UNITED STATES
NUCLEAR REGULATORY COMMISSION
WASHINGTON, D. C. 20555

APPLICANT: Public Service Electric & Gas Company (PSE&G)
FACILITY: Hope Creek Generating Station
SUBJECT: SUMMARY OF STRUCTURAL AND GEOTECHNICAL ENGINEERING
BRANCH (SGEB) MEETING

On August 1, 1984, a meeting was held in the Bethesda, Maryland offices of the NRC to discuss the remaining SGEB-Structural audit open items identified in the Draft SER. A list of meeting attendees is included as Enclosure 1 to this meeting summary.

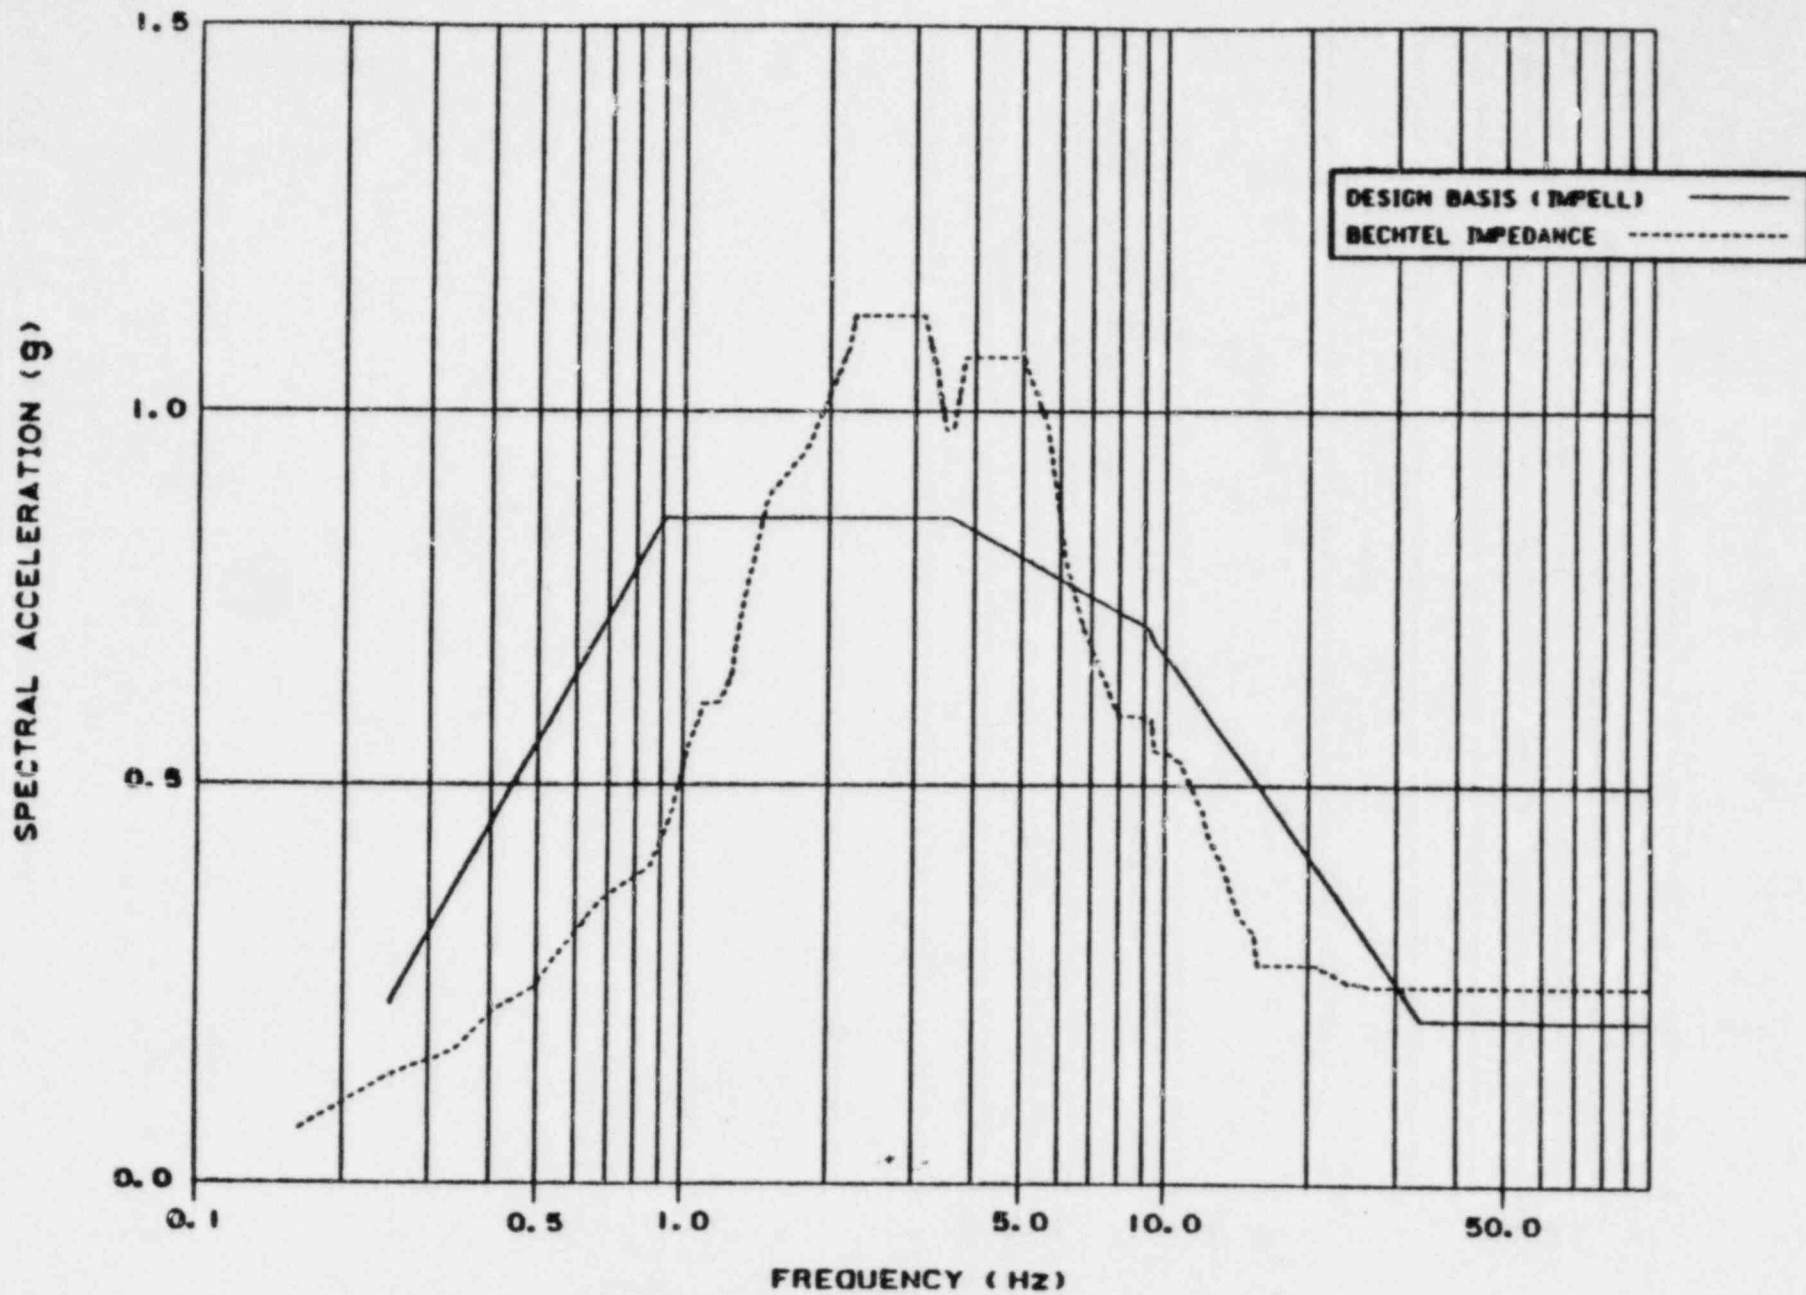
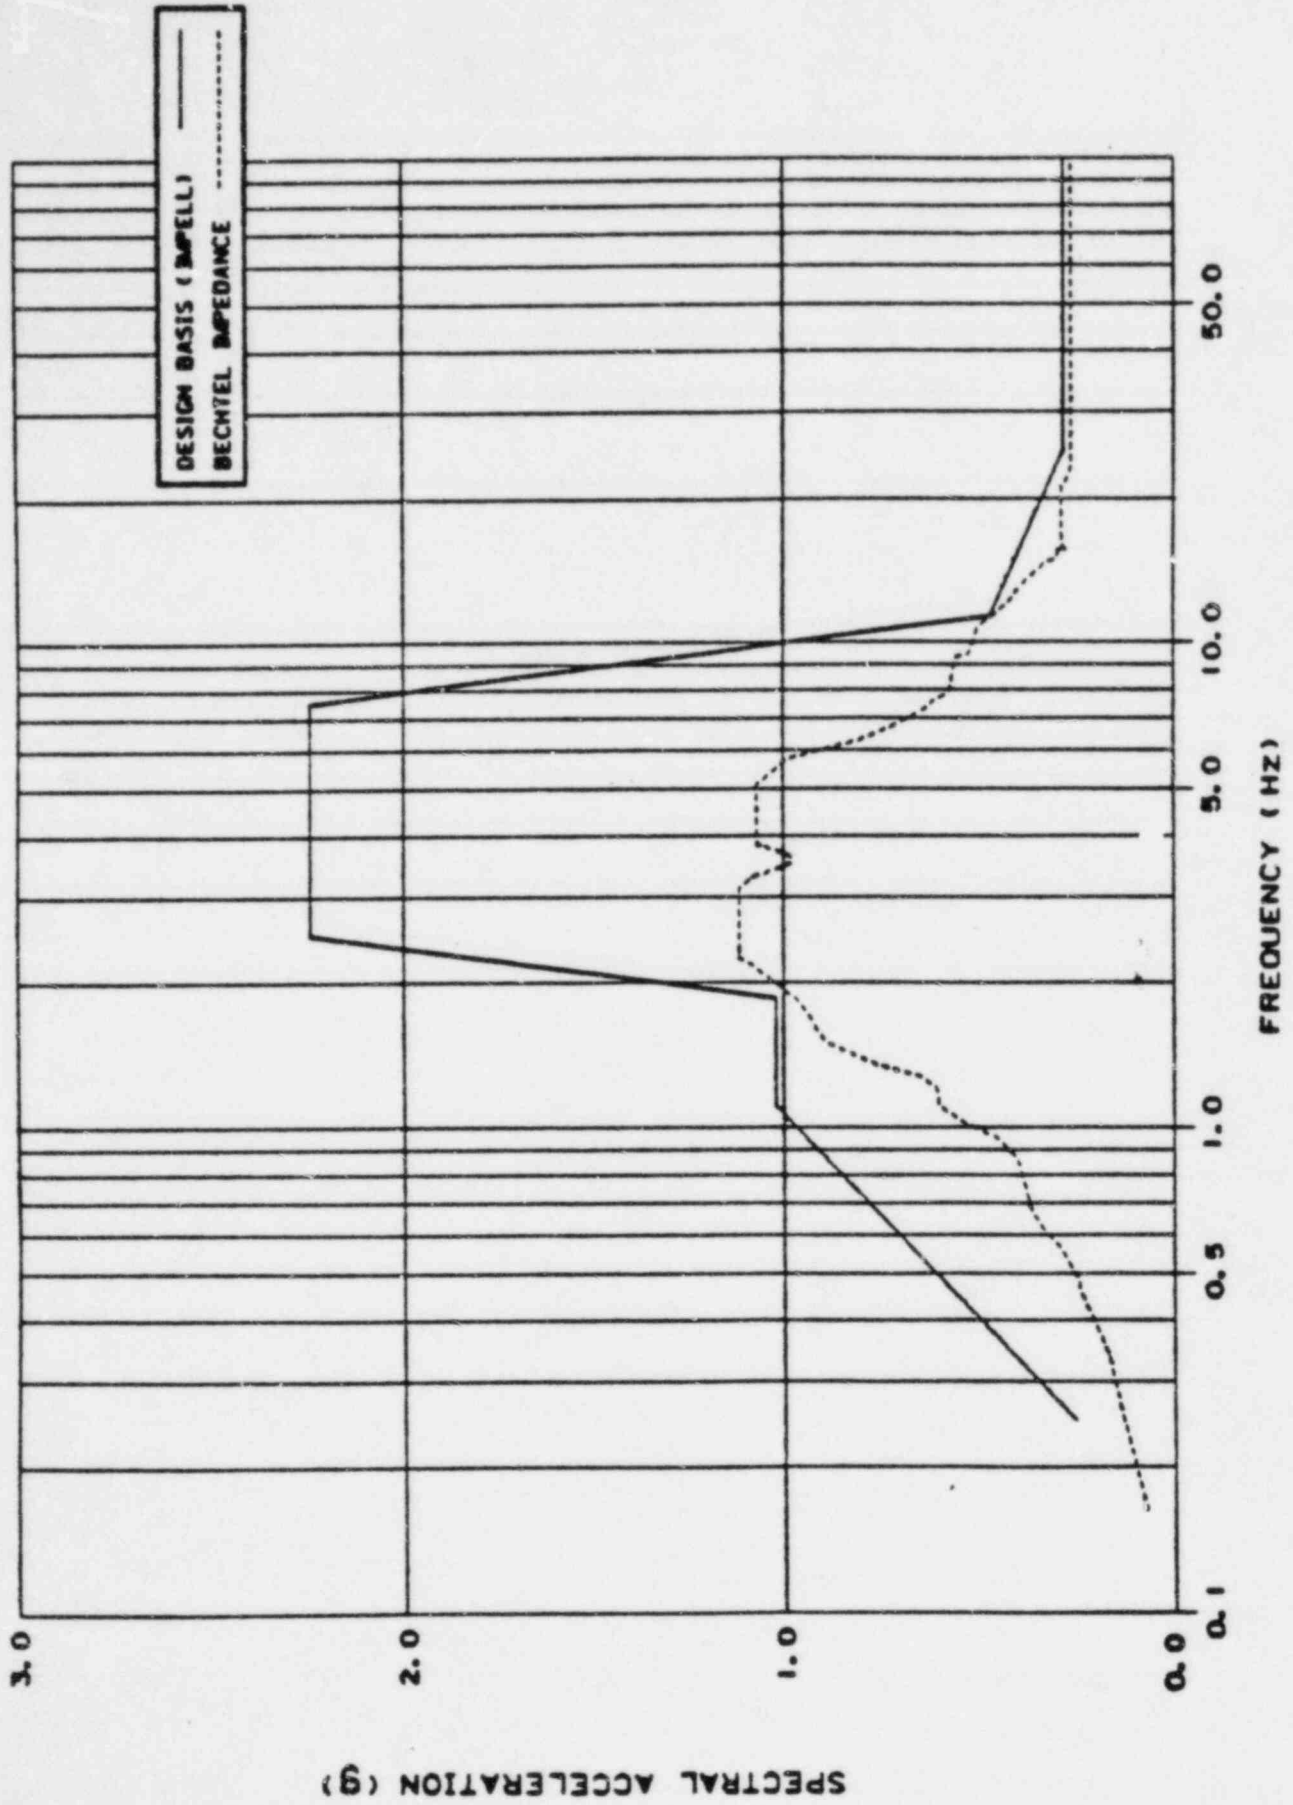
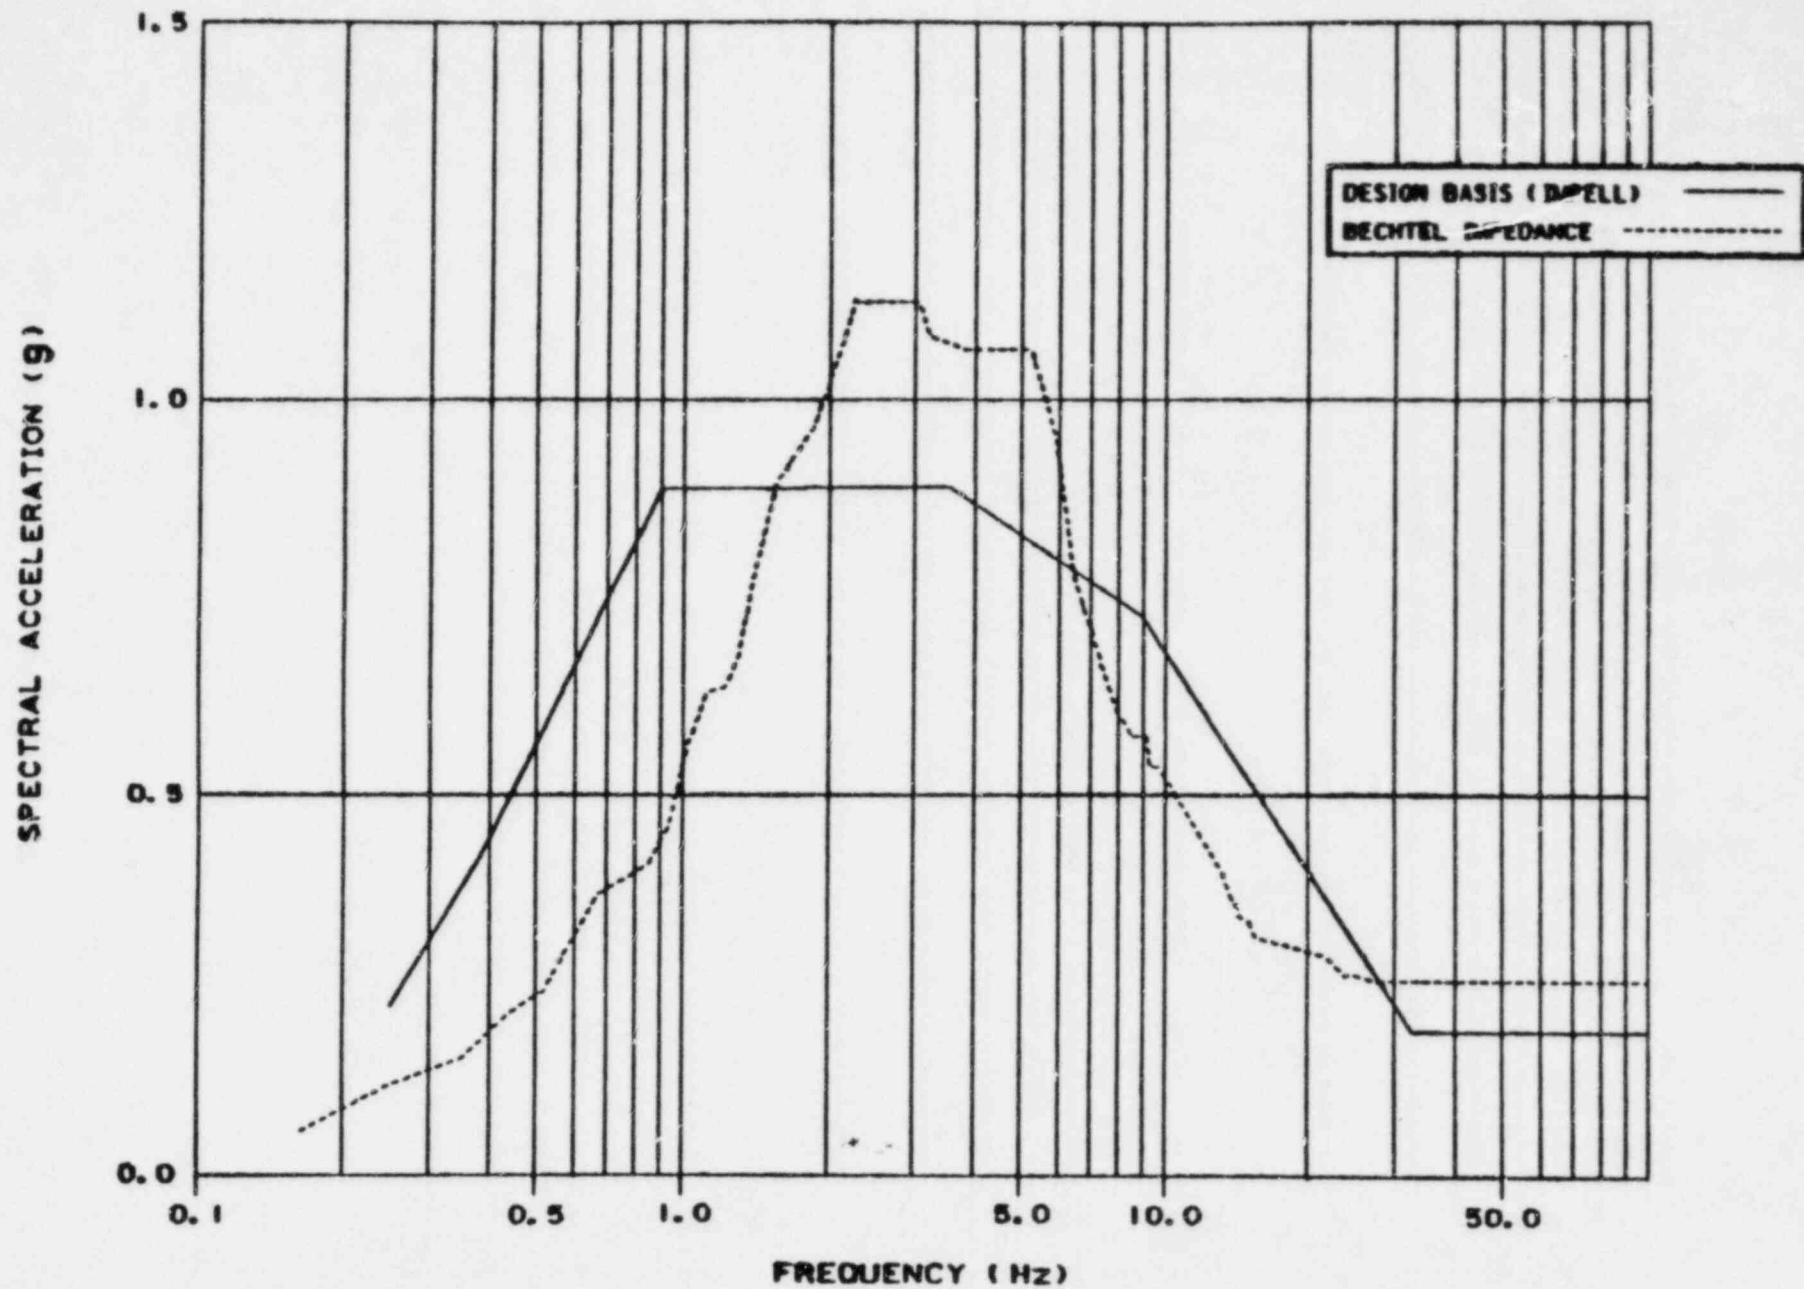
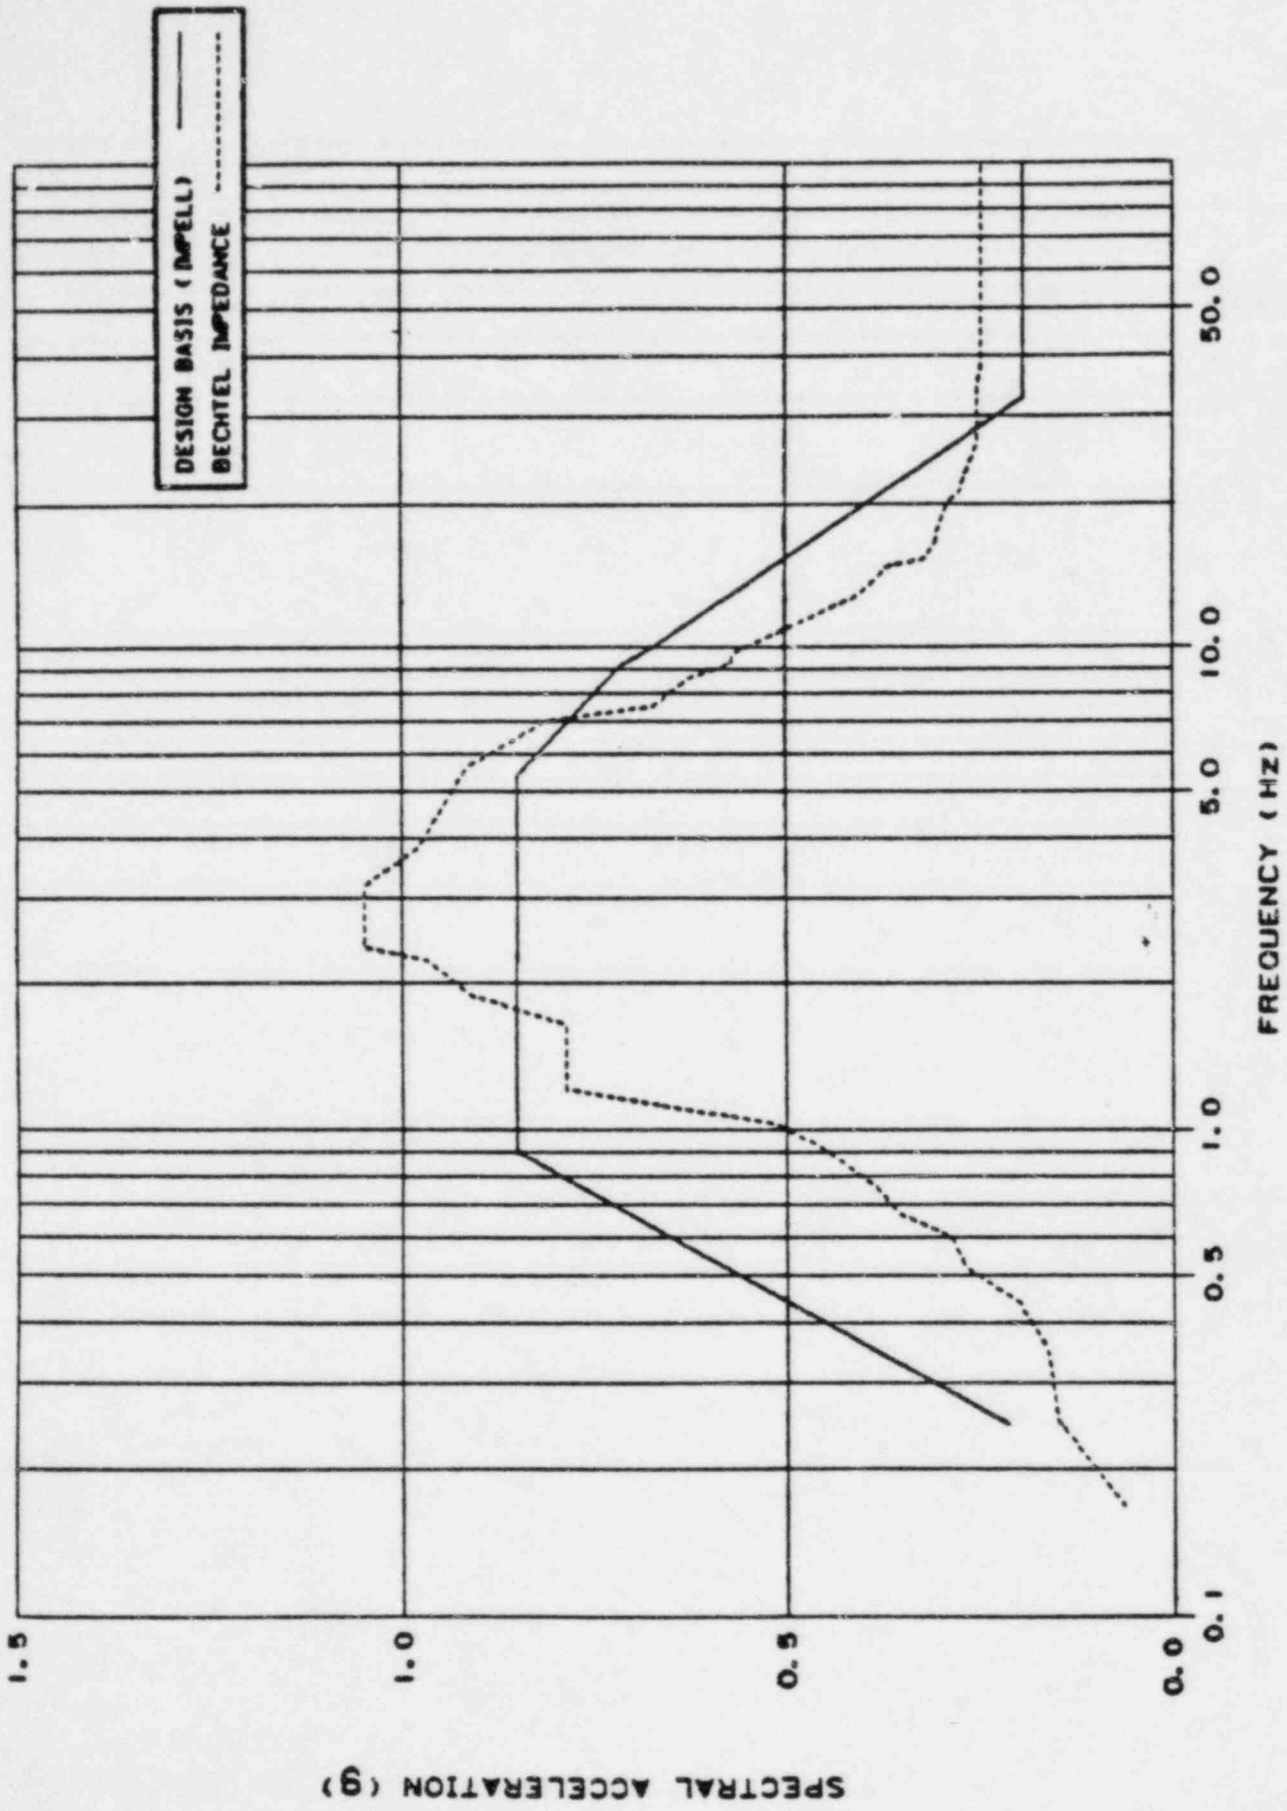
Question No.: A-16

Figures A-16-1 to A-16-18 show the comparison of the 2 percent damping response spectra obtained from the design basis finite element and the impedance approach seismic soil-structure interaction analyses. The impedance approach response spectra generally are enveloped by those obtained from the design basis analyses at elevation 114.0 feet of the SWIS. For other elevations, the impedance approach spectral accelerations exceed the design basis spectral accelerations in some frequency ranges. These ranges vary approximately between 1.5 and 10.0 Hz.
